LLOYD'S REGISTER OF SHIPPING

ALTERATIONS TO CONDITIONS OF ASSIGNMENT OF LOADLINES

Ship's Name LiverpoolOfficial No. ✓Port of Registry PanamaThis ship has been under survey at La Speziaon the 3rd Novemberand subsequently
1953and the following alterations to the conditions of assignment of loadlines have now been effected/^{on}found:—Alterations found

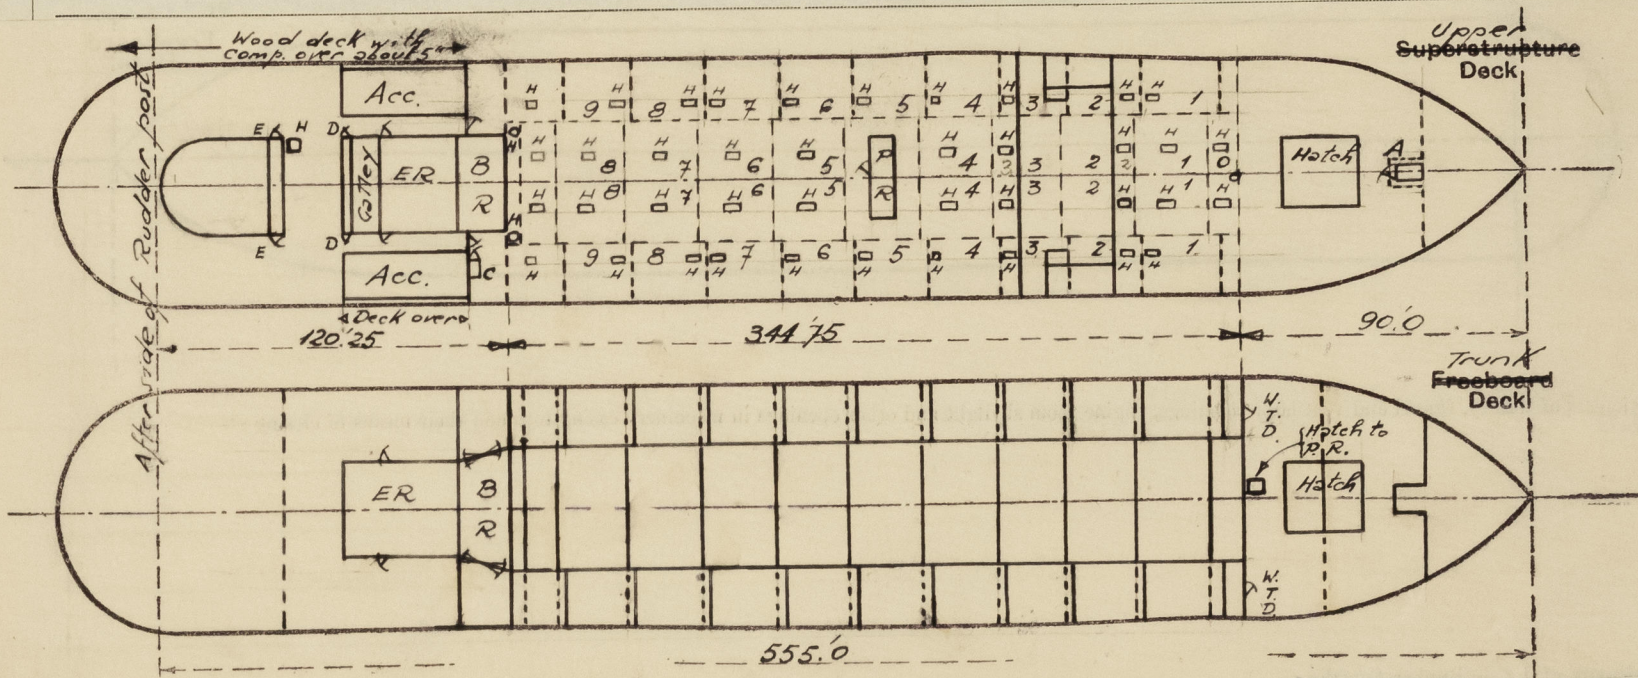
- 7) Six instead of 5 - 12" diam x 36" x .40 vents, provided with hinged steel W.T. covers, fitted aft of poop deckhouse. ✓
- ? — 8) Two round hatchways fitted on upper deck, leading to after deep copperdam. For particulars see sketch and table of particulars at the end of this Report

one new hatchway each side fitted to new stores aft of summer tanks. For particulars see sketch & table at the end of this Rpt.

The following sketches & table of particulars show hatchways and companionways as existing at this time and supersede the corresponding sketches & table in Rpt. CH:
